EXHIBIT 2 - STAFF REPORT

DATE: January 4, 2024
TO: Planning Commission Members
FROM: Tom Schauer, Senior Planner
SUBJECT: Public Hearing – Planned Development Amendment PDA 1-23, Subdivision S 1-23, Three Mile Lane Review TML 5-23

DECISION, CONDITIONS, FINDINGS OF FACT AND CONCLUSIONARY FINDINGS FOR THE APPROVAL OF A PLANNED DEVELOPMENT AMENDMENT, SUBDIVISION TENTATIVE PLAN, AND THREE MILE LANE REVIEW, FOR PROPERTY AT 235 NE DUNN PLACE, TAX LOT R4422CD 01700

DOCKET: PDA 1-23 (Planned Development Amendment)
S 1-23 (Subdivision Tentative Plan)
TML 5-23 (Three Mile Lane Review)

**December 7, 2023 Submittal**

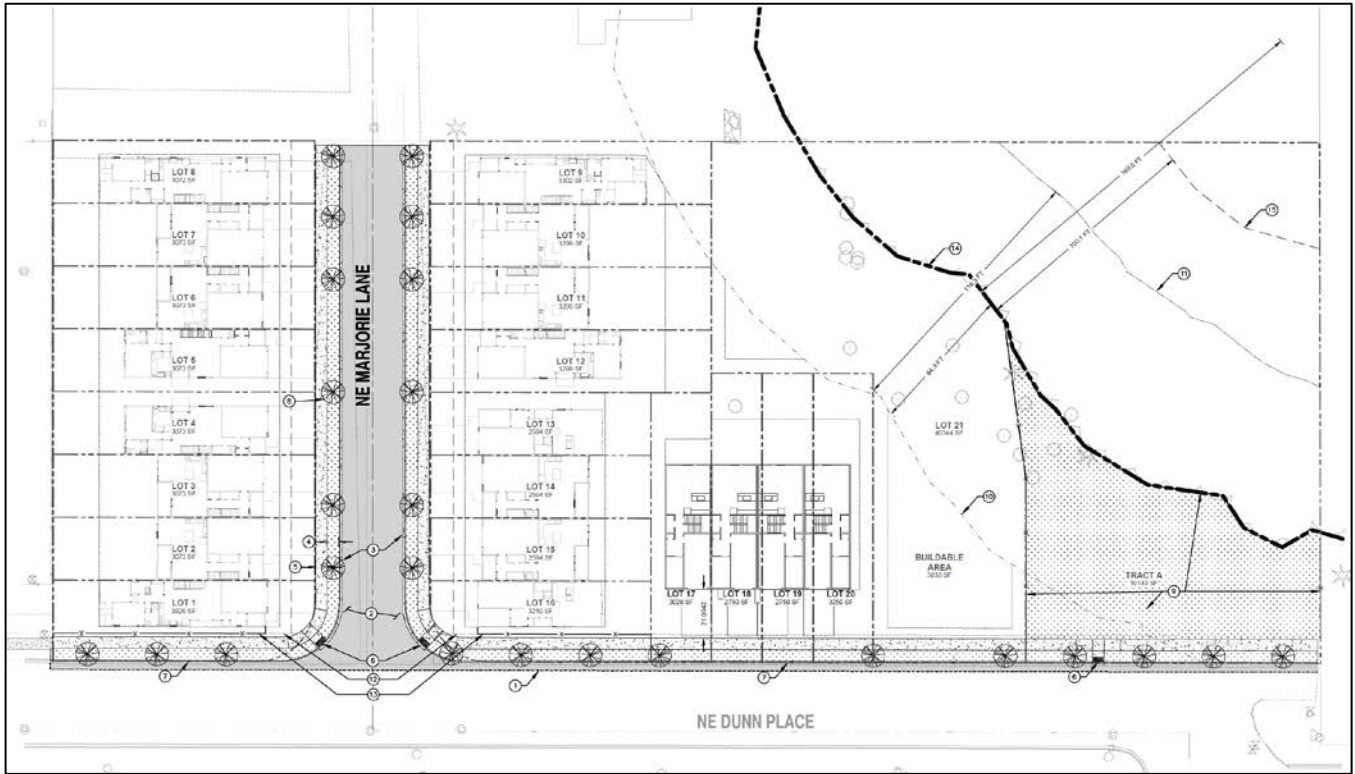
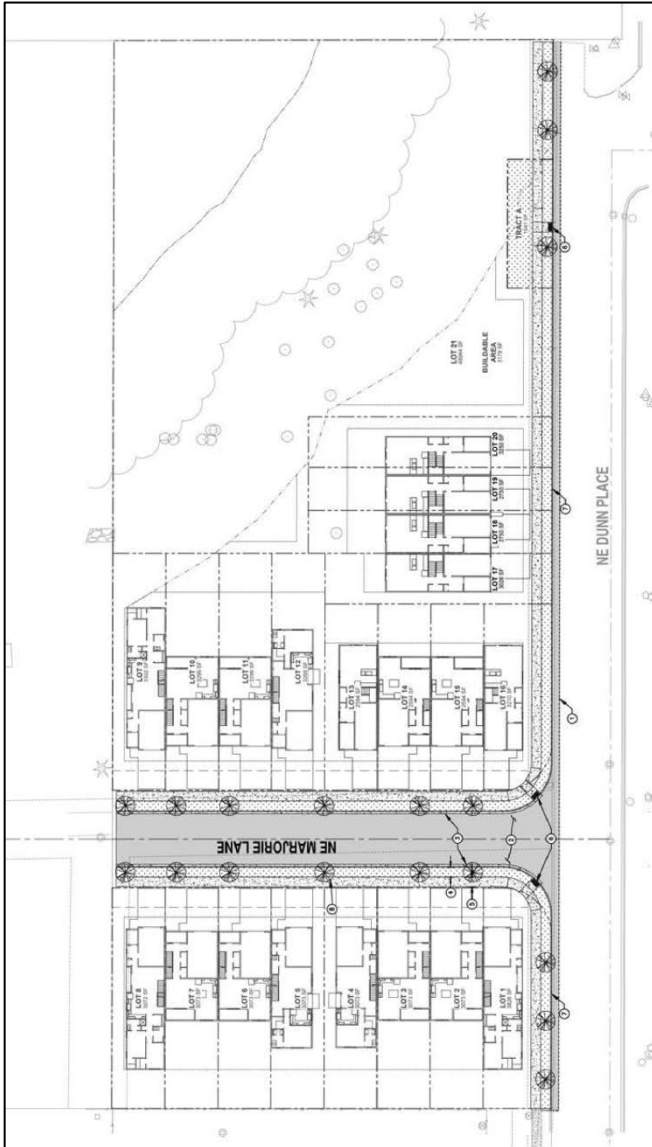
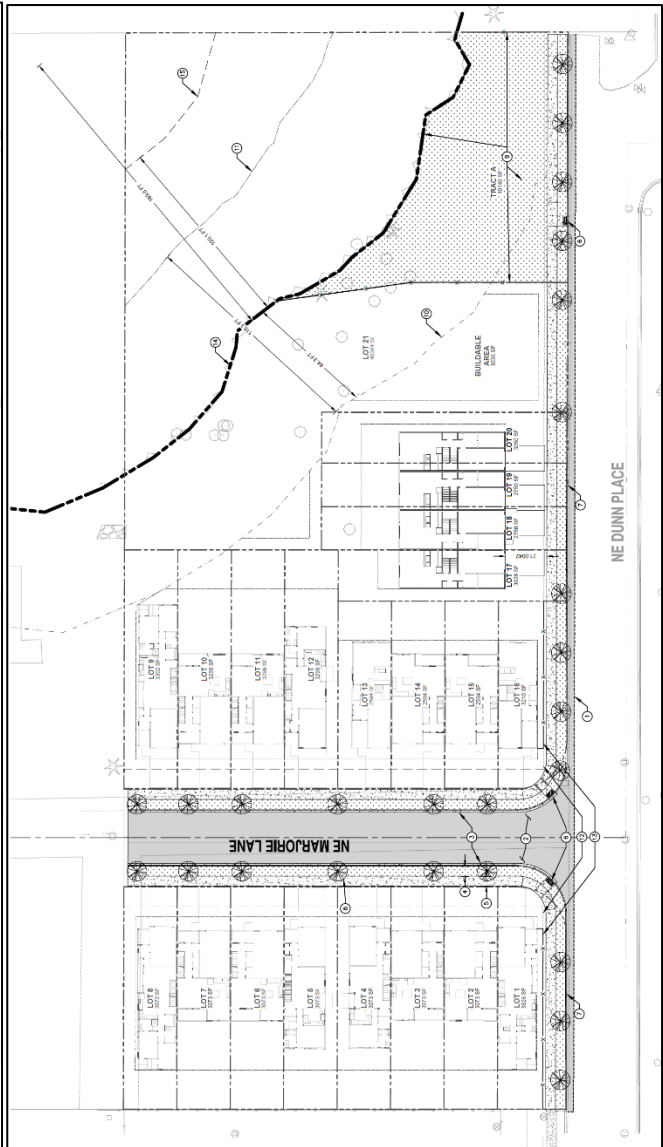
Most of the proposed structures would be more than 80 feet from top of physical bank, with the majority of those also exceeding 100 feet from top of physical bank. One unit, on Lot 9, shown as a 1-story unit is shown with the corner at the 60-foot setback. At the December 7 hearing, the applicant indicated that unit could be revised to a 2-story unit, which would have additional setback and also provide a larger usable rear yard outside of the 60-foot setback.

- **Rear of some lots extended into 60-foot setback area.** While the proposed townhouse structures were outside of the 60-setabck, three lots: 9, 10, and 20 have rear portions of the lots that extend into the 60-setback area, presenting questions about how fencing and small accessory structures, which are allowed within rear-yard setbacks, would be regulated.

Staff recommends a revised condition that those lots be reconfigured so those lots do not extend into the 60-foot setback. This condition is incorporated in the revised decision document.

At the December 7 hearing, the applicant indicated the proposed townhouse on Lot 9 could be revised to a 2-story unit, which would leave a usable rear yard similar to the other 2-story units. Lots 10 and 20 would continue to have usable rear yards if adjusted.

9. The plan shall incorporate the 60-foot setback shown in the plans.
10. The plans show a portion of the 60-foot setback encroaching into rear yards of lots 9, 10, and 20. The applicant shall revise the lots so they don't encroach into the 60-foot setback. Lot 9 shall be revised to a 2-story unit to provide a 20-foot usable rear yard area.
